Rev2 Notes:

Orderable: N/A	Designed for: Public Release	Mod. Date: 12/31/2020
TID #: N/A	Project Title: UCC5870 Gate Driver for Traction Inverter	
Number: EVT_011	Rev: E2	Sheet Title:
SVN Rev: X	Version control disabled	Assembly Variant: 001
Drawn By: X.Gong		File: InvGateDriver_1.SchDoc
Engineer: X.Gong		Contact: http://www.ti.com/support

Rev2 Notes:

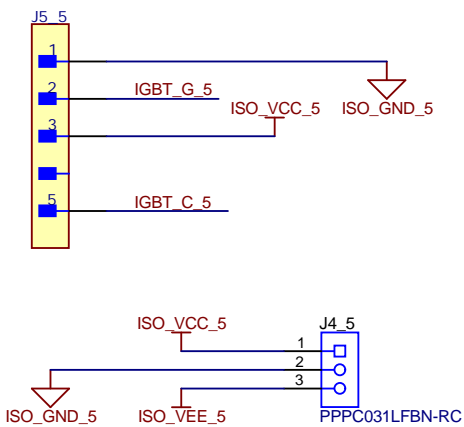
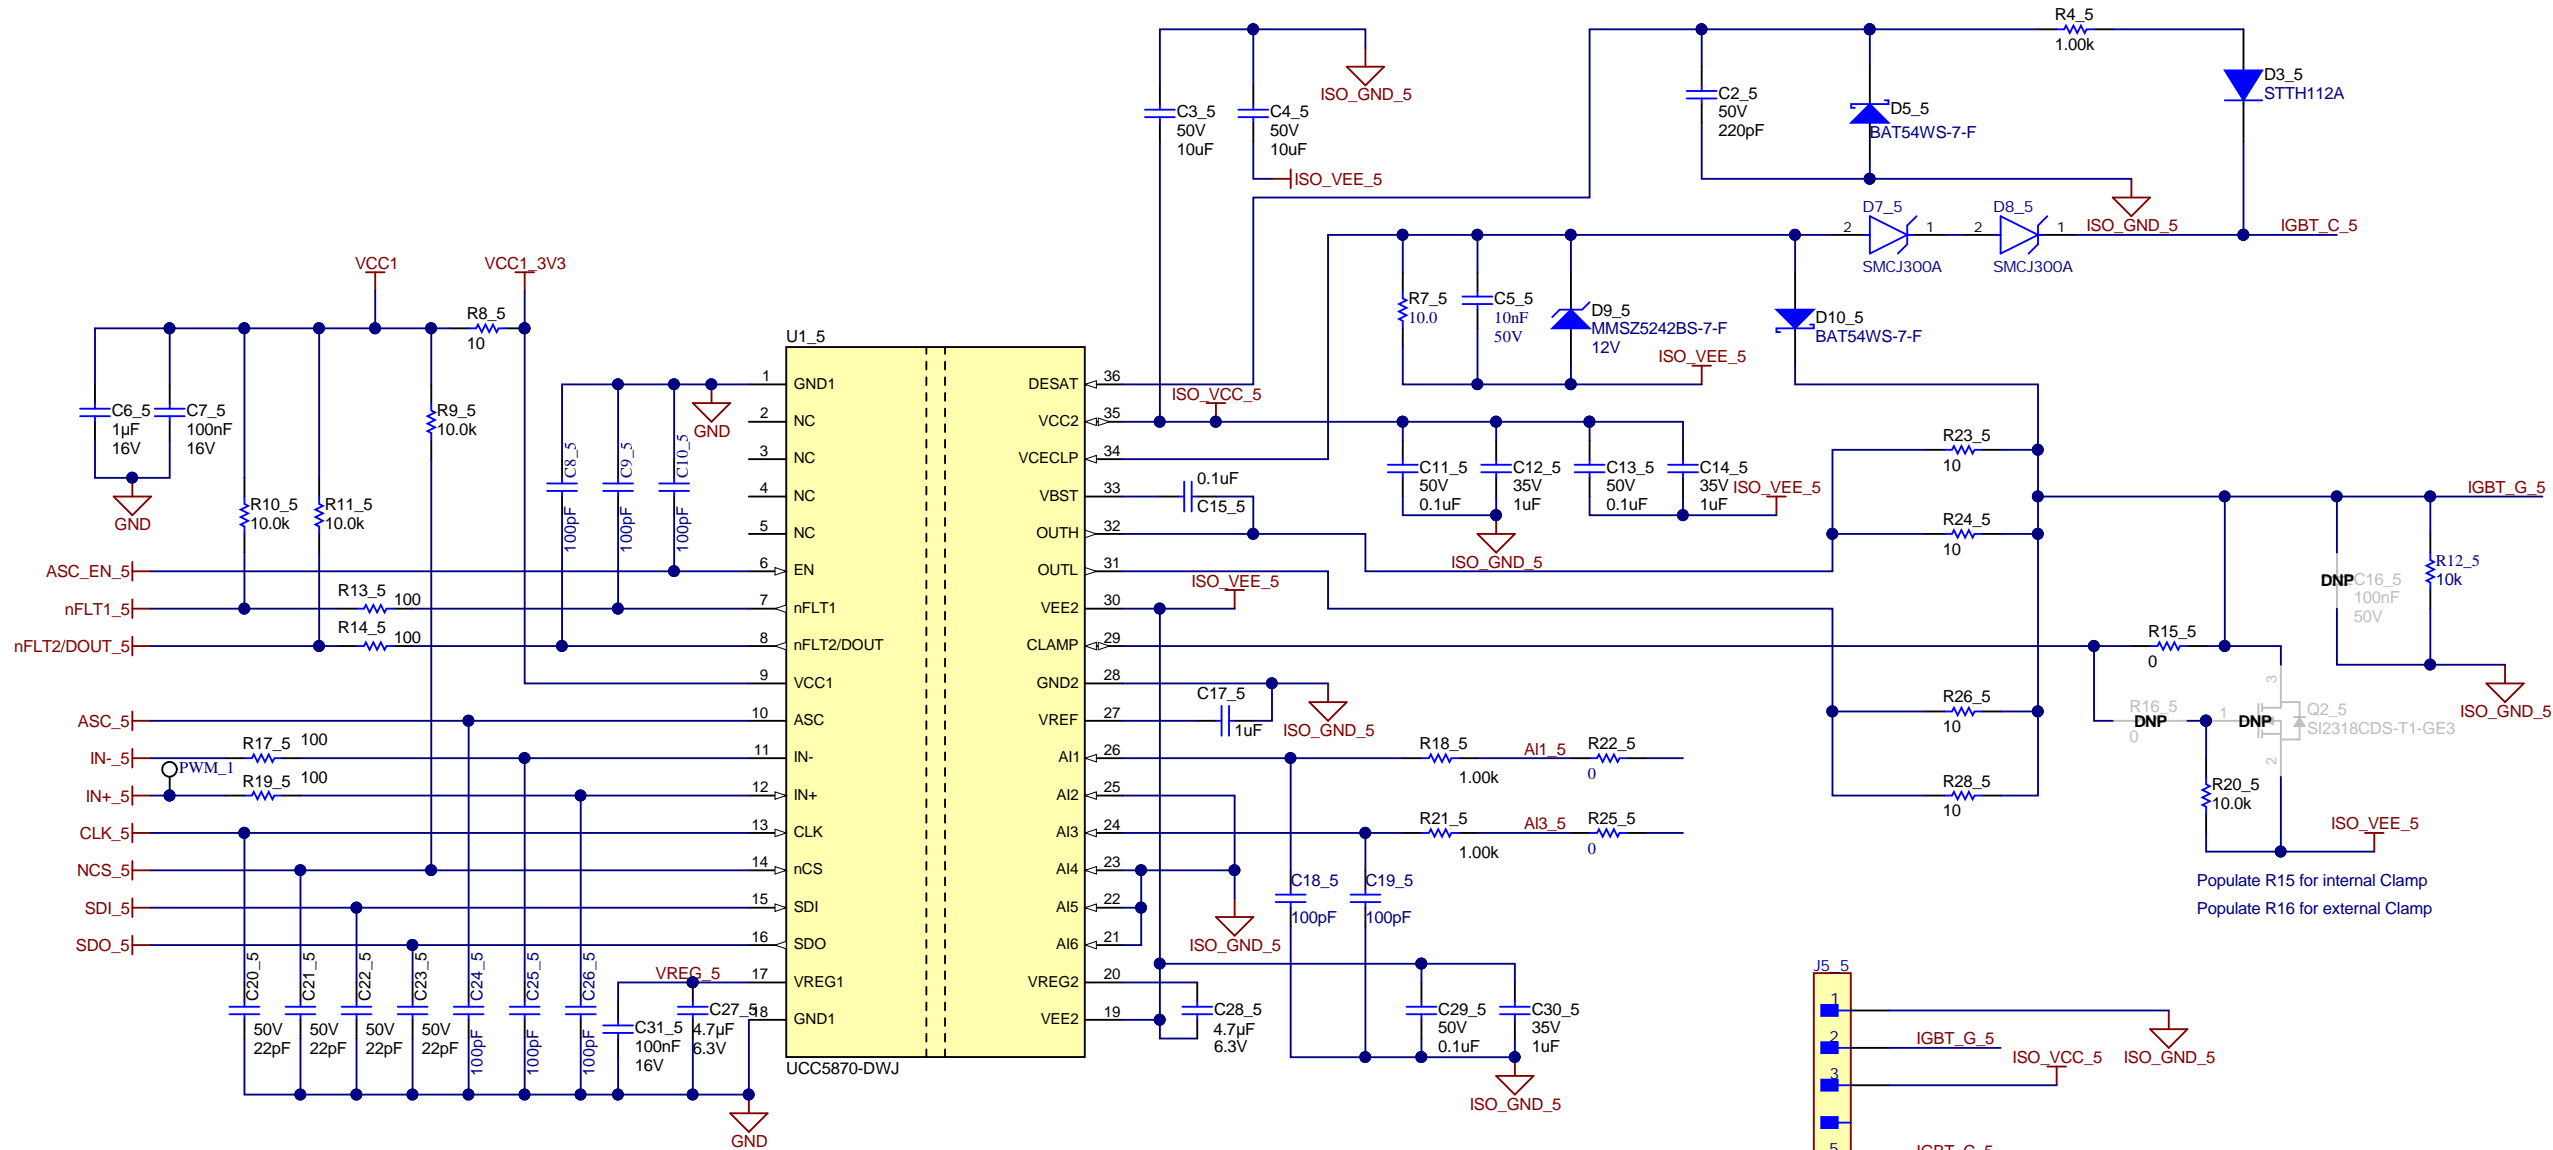
- 1). Pin27 (VREF) should be connected to C17 only, not to the VEE2 pin. The wiring got shifted around when drawing the schematic and got wrongly connected.
- 2). Pin 20 (REG2) should be connected to ISO\_VEE through the 4.7uF capacitor, instead of to ISO\_GND.
- 3). C18 and C19 may be replaced with 0E resistor if noisy shutdowns were to happen through these lines
